**Title: Combined Stage 1&2 Road Safety Audit
For;
Proposed Residential Development –
Caisleán Raithin, Ardrahan, Co. Galway.**

Report reference: 1193R01

VERSION: FINAL (Dec 2022)

Drawing 18337/CE/004/PL, Site Layout Plan.

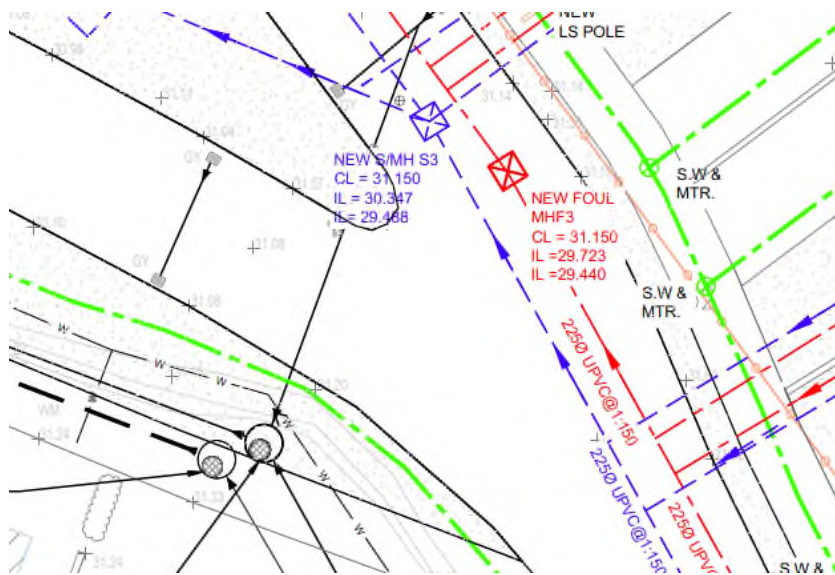
The one-way system may not be clear to visitors to the estate. This could lead to head-on collisions.

It is recommended that some road markings be provided to show travel direction and priority at the merge point of the loop.

Drawing 18337/CE/004/PL, Site Layout Plan.

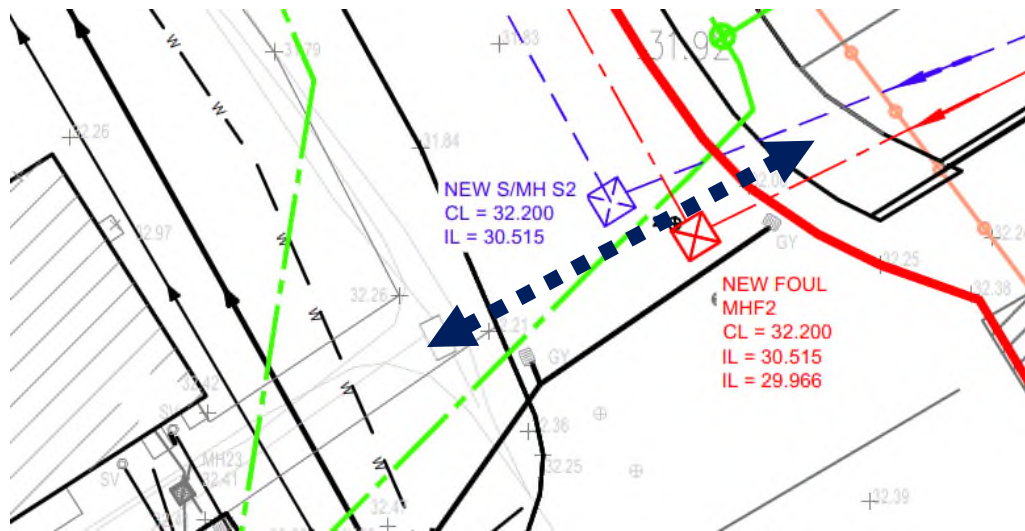
There will be a pedestrian desire line across the access to the development to the proposed footpath outside unit no.2 which currently does not exist. Crossing the carriageway may lead to trips and falls.

It is recommended that an uncontrolled pedestrian crossing be provided with dropped kerbs and suitable tactile paving.

Problem Location Plan.

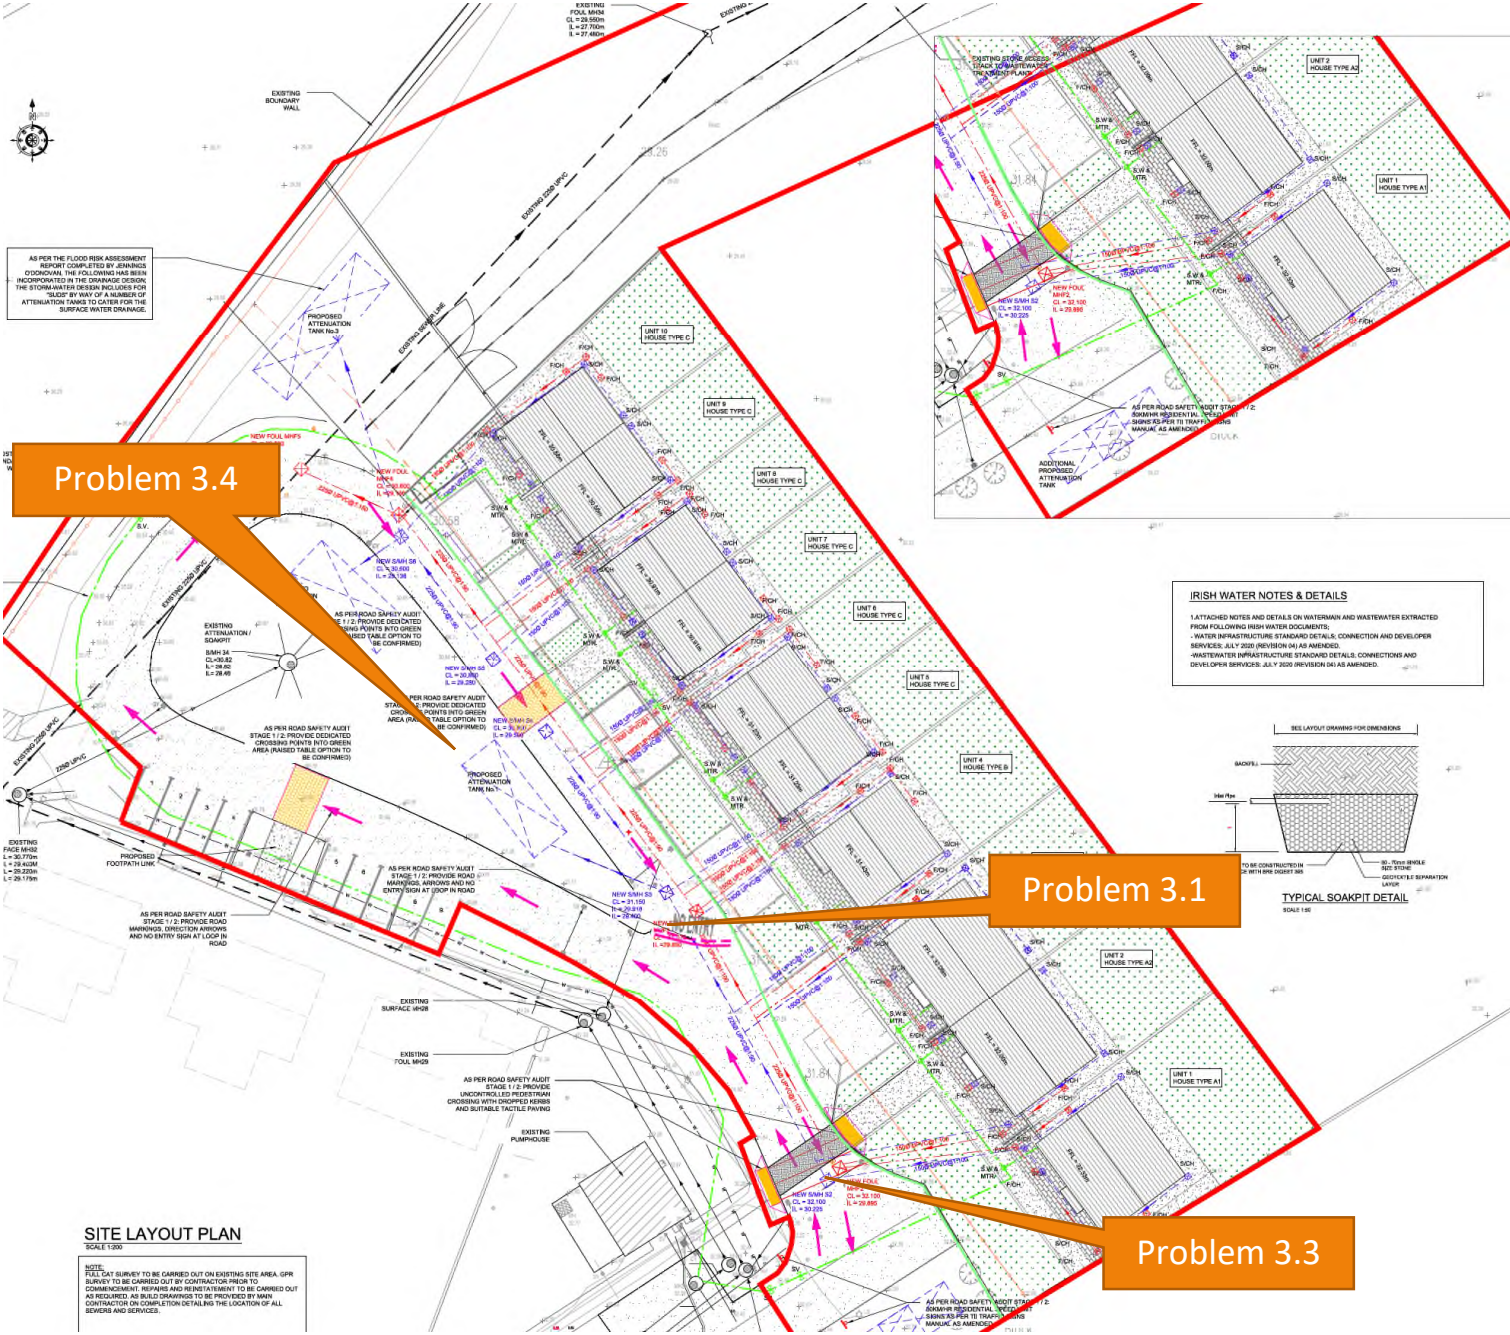
It is assumed that the green island area will be used as a play area for children. There is a risk that children will cross the carriageway at various locations and may not be seen by drivers reversing out of the on curtilage parking spaces.

It is recommended that dedicated crossing points be provided possible with raised tables to highlight their presence and to provide a courtesy crossing for children.
